**NRC RAI Letter No. PTN-RAI-LTR-061 Dated May 17, 2012**

**SRP Section: 03.07.01 – Seismic Design Parameters**

**NRC RAI Number: 03.07.01-14 (eRAI 6432)**

**NRC RAI Number: 03.07.01-15 (eRAI 6432)**

**Figure 4.3-1**  
**Turkey Point 2D Fine SASSI Model (not to scale)**

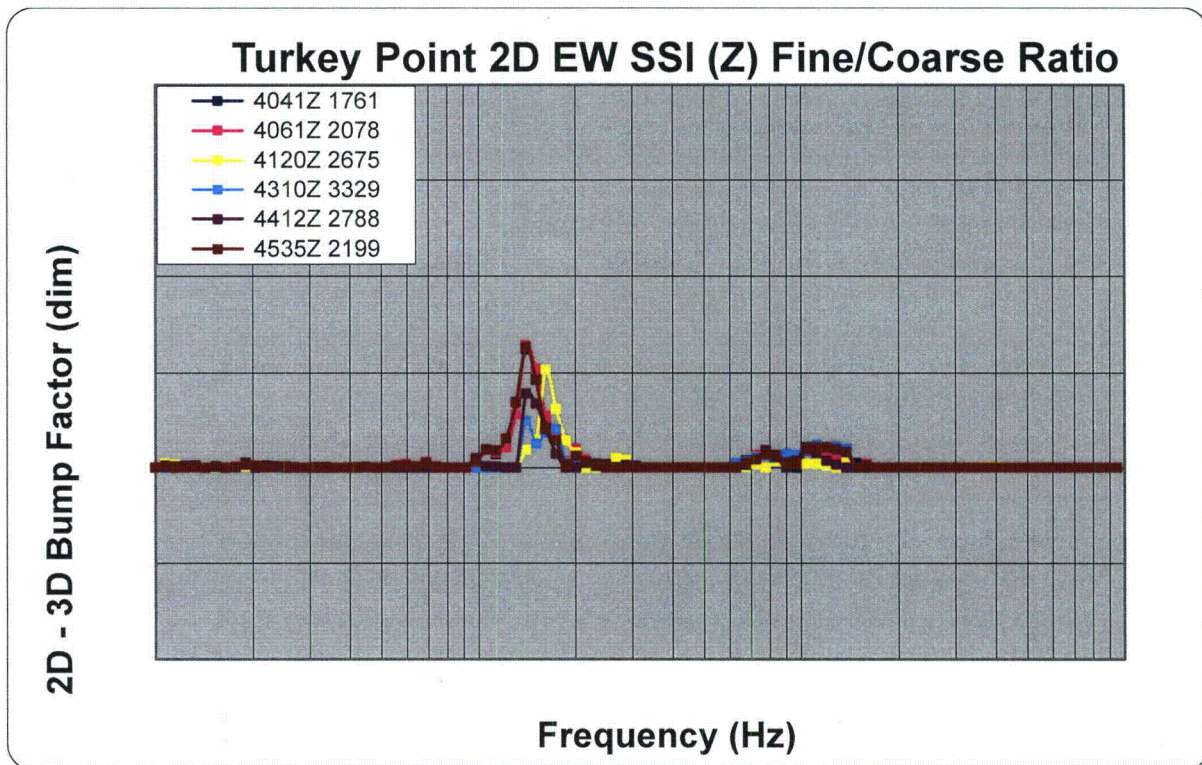
In Revision 3 of the applicant's FSAR, (aka. TPG-1000-S2R-802, "Turkey Point Site-Specific Seismic Evaluation Report") Figure 3.1-2 shows the lean concrete bridging mat extending approximately 30 ft beyond the reinforced concrete base mat of the NI. The staff believes that including the unreinforced bridging mat in the SSI analysis as a continuous 'structure' can result in an increase in the translational impedance of the SSI system of roughly 50% as well as a large increase in the rocking impedance. If in fact the material is 'non-structural' and cracks at the face of the NI, the resulting stiffness (and frequency) of the NI/soil system may be significantly overstated by the modeling approach used.

The Staff requests that the applicant demonstrate that the stresses are sufficiently low in the supporting mat to preclude cracking of the mat or provide an assessment of the affect of potential cracking of the mat on the SSI responses computed for the NI structures.

The lean concrete fill does extend approximately 30 ft beyond the reinforced concrete foundation of the NI. The lean concrete fill is unreinforced and was modeled as a continuous layer in the three-dimensional (3D) soil-structure interaction (SSI) analysis of the NI. However, as shown in Figure 4.3-1 of TPG-1000-S2R-802 Rev. 5 and presented below, the lateral extent of the lean concrete fill was modeled in two-dimensional (2D) parametric SSI analyses of the NI, and the 2D model/analysis included lateral boundary conditions beyond the extent of the lean concrete fill. Thus,

the limits of the lean concrete fill are modeled, the response evaluated, and potential impedance effects accounted for in the 2D parametric analysis, which compares the in-structure response spectra (ISRS) from the embedded portions of the 3D continuous and 2D expanded models/analysis.

The issue of the potential increase in the translational impedance of the SSI system and uncertainty or increase in the rocking impedance, as well as passing frequency and mesh-related filtering were accounted for in the development of the 2D-to-3D, frequency-dependent Bump Factors. In Revision 5 of the report, the Bump Factors ranged from 1.0 to 1.5 horizontally and 1.0 to 1.7 vertically at the six (6) key NI locations. Bump factors shown in Figures 6.1-1 and 6.1-2 of the Revision 5 report (and shown below) were applied to the 3D SSI ISRS for all three soil profiles including the best-estimate (BE), lower-bound (LB) and upper-bound (UB) cases. ISRS are further broadened by  $\pm 15$  percent and subsequently compared to the AP1000 CSDRS and HRHF envelopes at the six (6) key locations of the NI.

Further, any uncertainty associated with the stiffness (and frequency) of the NI/soil system and/or potential cracking of the lean concrete fill due to rocking of the NI was accounted for in the SSI analyses by utilizing a range of concrete shear wave velocity ( $V_s$ ) properties from the LB  $V_s=4506$  feet per second (fps) to an UB  $V_s=6759$  fps. The approximate  $\pm 20$  percent range in concrete  $V_s$  properties accounts for potential degradation due to cracking around the BE concrete  $V_s$  of 5519 fps. Additionally, the BE, LB and UB ISRS were factored by the 2D-to-3D frequency-dependent Bump Factors, and all cases were conservatively broadened by  $\pm 15$  percent as described above for comparison to the CSDRS and HRHF envelopes.

Figure 2.1-2  
TPNP FIRS and RG 1.60 PGA=0.1g Foundation Level Outcrop SSE

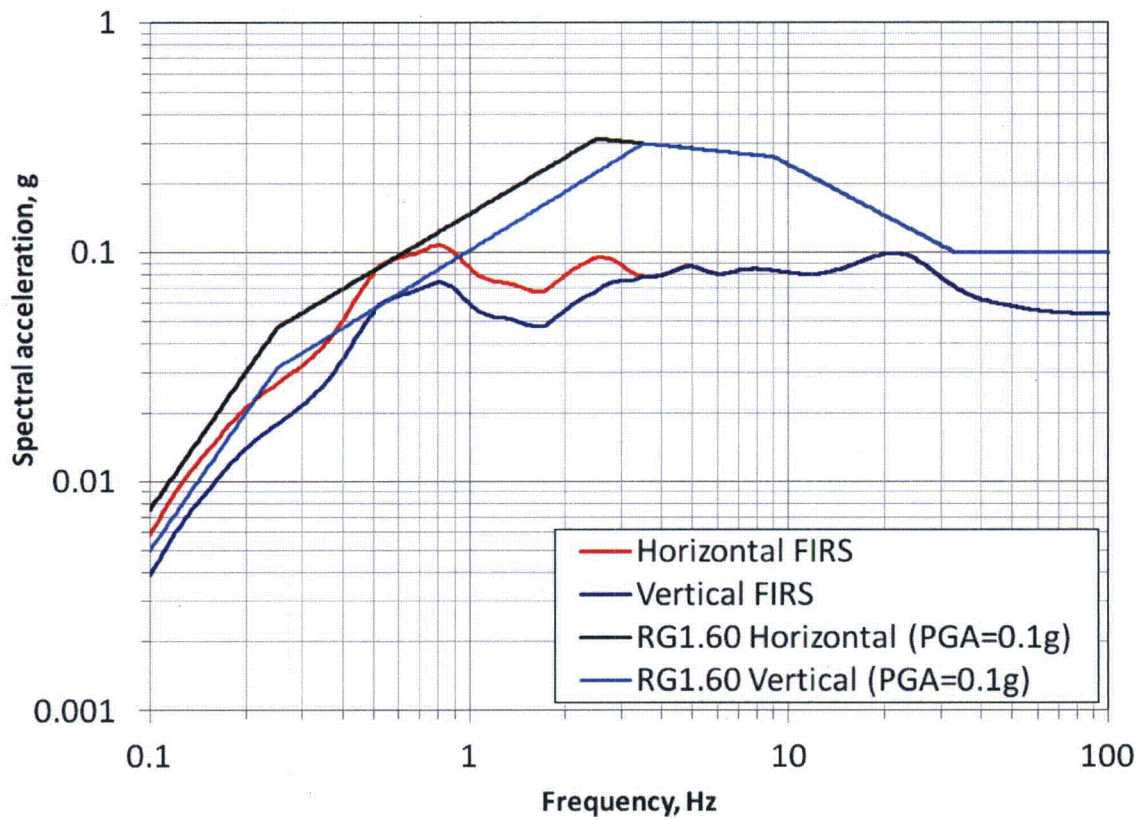
In Revision 3 of the applicant's FSAR, (aka. TPG-1000-S2R-802, "Turkey Point Site-Specific Seismic Evaluation Report") Figures 2.1-3 through 8 show the response spectra at the foundation level. These spectra have  $z_{pa}$  values that are less than the 0.1g at the foundation depth that is required by Appendix S to 10 CFR Part 50. (Note that this issue was previously identified in a question on Figure 2.5.2-252 regarding the input motion at Elevation -35). The response spectra shown in those figures form the basis of the input motions that are used to compute the in-structure response spectra (ISRS) from the SSI analyses. Meeting the Appendix S requirements would appear to require adjusting the input motions upward which would result in margins, as compared to the DCD ISRS at the six key locations, to reduce significantly from those indicated in the tables mentioned above. Additionally, it is noted in the AP1000 DCD that the CSDRS is at finished grade. Since the input motion at the foundation level is less than the minimum required by Appendix S, the surface spectra shown in Appendix 3JJ, which neglect any adjustment required to satisfy Appendix S, appear to be understated. Thus, the applicant is requested to provide a discussion as to how the results provided in Appendix 3JJ and Figures 2.1-3 through 8 meet the Appendix S to 10 CFR Part 50 requirements for minimum seismic input at the foundation level.

To satisfy the requirements of Appendix S to 10 CFR Part 50, specifically that the Safe Shutdown Earthquake (SSE) motion must be an adequate acceleration response spectra (ARS) with a minimum peak ground acceleration (PGA) of 0.1g, the Turkey Point Units 6 & 7 site-specific design response spectra (DRS) at the foundation level (El. -16 ft) consists of the envelope of the Turkey Point site-specific foundation input response spectra (FIRS) and the RG 1.60 spectra scaled to 0.1g. The resulting outcrop horizontal and vertical envelope FIRS is considered the SSE motion for the Units 6 & 7 site meeting the minimum 0.1g PGA. The horizontal and vertical Turkey Point site-specific FIRS and RG 1.60 spectra envelopes scaled to 0.1g are presented in Figure 2.1-2.
